**City of Phoenix**  
AVIATION DEPARTMENT  
PLANNING & ENVIRONMENTAL DIVISION

June 24, 2026

**SUBJECT: Opposition to Phoenix Area FAA Modernization Project; Request to Revise and Re-Publish the Draft Environmental Assessment and Delay IFP Scheduled Publication**

a. SDL WF SIDS (All)

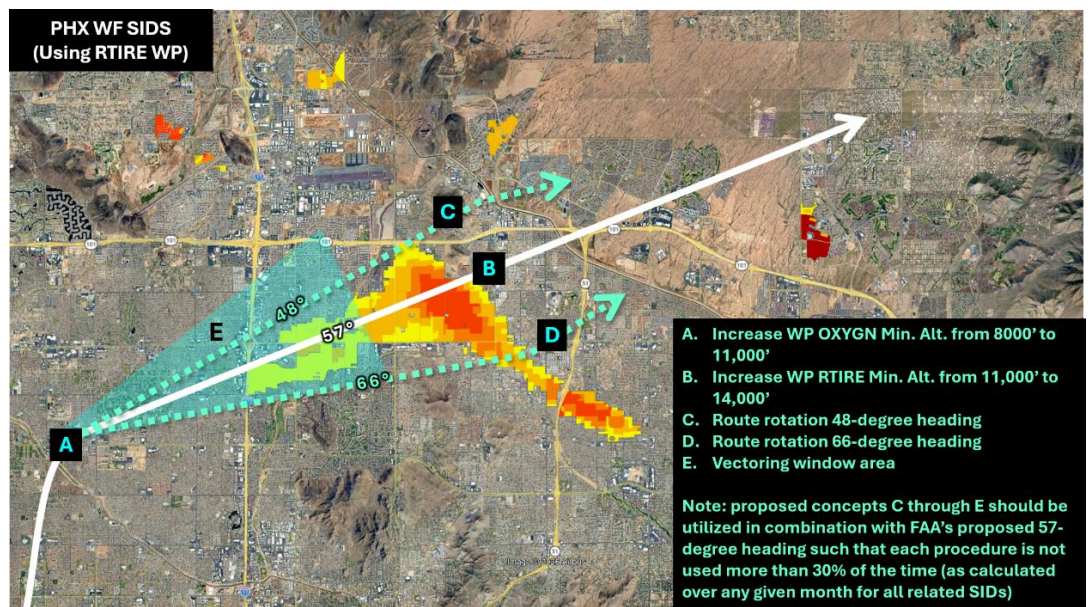
6. Produce a revised DEA that includes route alternatives and noise diffusion/dispersion programs by holding formal PBN working group meetings to analyze for flyability, environmental impact and consistency with the DEA purpose and need (ie, net benefit for reducing controller workload) the following proposed route modifications (ie, waypoint altitude minimum level increase), conceptual routes for noise dispersion/diffusion through route rotation programs and noise dispersion/diffusion through vectoring window programs:

## e. PHX GROUP B WF SIDS (ALL)

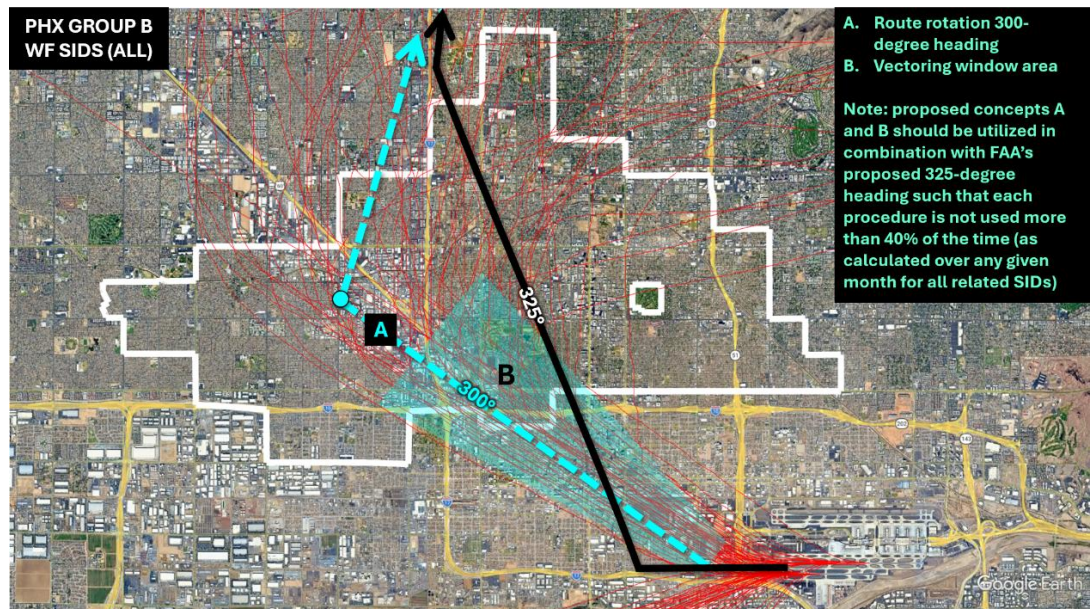
The proposed action includes new standard instrument departures for Group B aircraft from PHX. These procedures are not required to adhere to the noise abatement gates mentioned above. The proposed procedures for NW, SW, NE and SE flows are significantly different from existing lateral locations; in most instances the proposed procedure appears to create a corridor over an area that is less compatible (more noise sensitive) as compared to the general location of the VFR procedures under existing conditions. Moreover, the proposed procedures appear to be held at or below 3000' AFE for several miles beyond where these aircraft climb above 3000' AFE under existing conditions.

To be clear, these procedures in NW flow directly impact Phoenix Historic Districts and in SW flow may directly impact Environmental Justice Communities. Similar impacts are expected in NE and SE flow to neighborhoods in Scottsdale and Tempe east of PHX. The Project process must be paused so PBN working group stakeholders can look at dispersion/diffusion/rotational routing for these corridors, study alternative environmental impacts and review those new alternative actions with the Community prior to publication of the Final EA.
